ITEM #: 6.5	COMMITTEE OF ADJUSTMENT REPORT MINOR VARIANCE APPLICATION A175/22 17 Oakbank Rd, Thornhill
--------------------	---

COMMITTEE OF ADJUSTMENT REPORT
MINOR VARIANCE APPLICATION
A175/22
17 Oakbank Road, Thornhill

ITEM NUMBER: 6.5	CITY WARD #: 5
APPLICANT:	Mike Steiner
AGENT:	Zero Degree Studio Inc.
PROPERTY:	17 Oakbank Rd Thornhill ON
ZONING DESIGNATION:	See Below
VAUGHAN OFFICIAL PLAN (2010) DESIGNATION:	Vaughan Official Plan 2010 ('VOP 2010'): "Low-Rise Residential"
RELATED DEVELOPMENT APPLICATIONS:	None
PURPOSE OF APPLICATION:	Relief from the Zoning By-law is being requested to permit the construction of a cabana, changeroom/washroom and installation of pool equipment. Relief is also requested to permit increased maximum driveway width and a retaining wall.

Drawn by	RC
Date	2022-01-08
Scale	1 : 100
Project Number	21022
DRAWING NAME	SITE PLAN
SHEET NUMBER	SD1

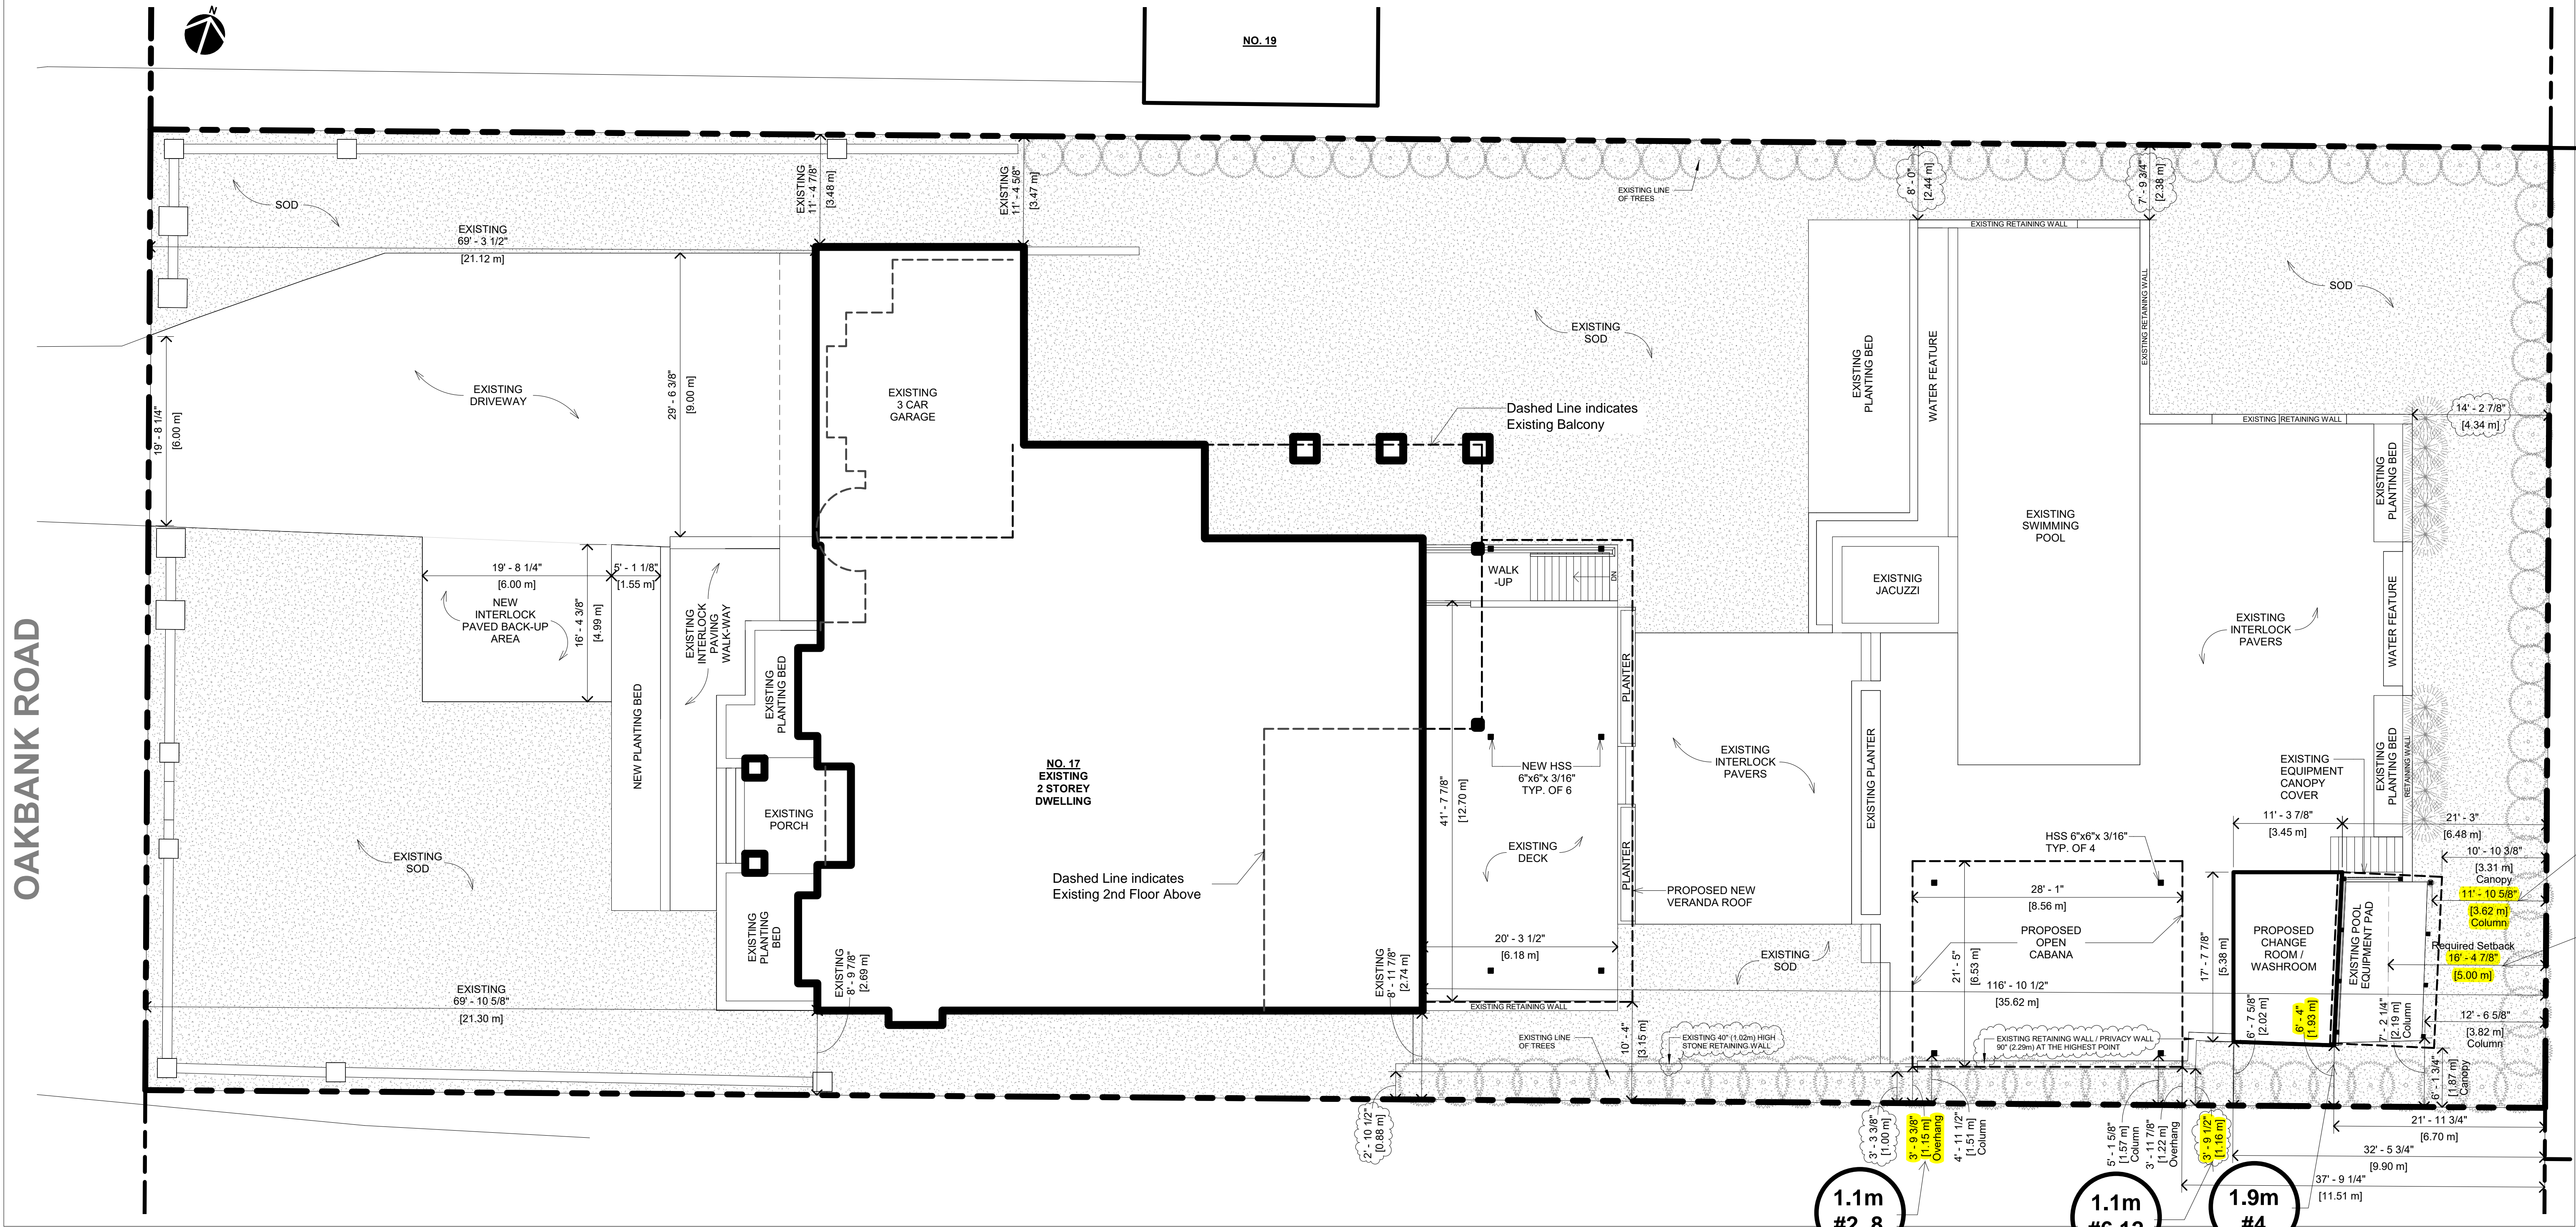
The Development Planning Department (Development Planning) does not object to Variances 2, 4, 8, and 10, as the accessory structures provide setbacks that do not impact the functionality and accessibility of the rear yard, remain consistent with other

approved structures in the area, and are surrounded by a vegetative buffer that helps reduce any massing impacts to the abutting properties. Variances 5, 6, 11, and 12 recognize setbacks that were approved through A131/11, with the minor change being the pool equipment is now proposed to be covered. Provided the lot has operated with these reduced setbacks for over 10 years with unenclosed pool equipment, the Development Planning considers these requests to be appropriate and an improvement with respect to potential noise impacts.

With respects to Variances 1 and 7, the two-storey dwelling (with garage) occupies 15.9% of the total lot coverage, while the remaining 8.8% is associated with the proposed covered front porch, rear covered deck, cabana, change room and above grade basement gymnasium. Due to the shift in grade on-site, approximately two feet of the basement gymnasium under the rear deck sits above the established grade, which contributes to maximum lot coverage. A proposed total lot coverage of 24.7% facilitates a development that is compatible with and preserves the character of the neighbourhood.

Development Planning acknowledges the maximum coverage area discrepancy between Variances 3 and 9 comes from the fact By-law 001-2021 excludes covered areas that are attached to the main dwelling (rear covered deck). Additionally, the cabana is proposed to be unenclosed and complies with the maximum height provisions minimizing the possibility of impacting the adjacent lots.
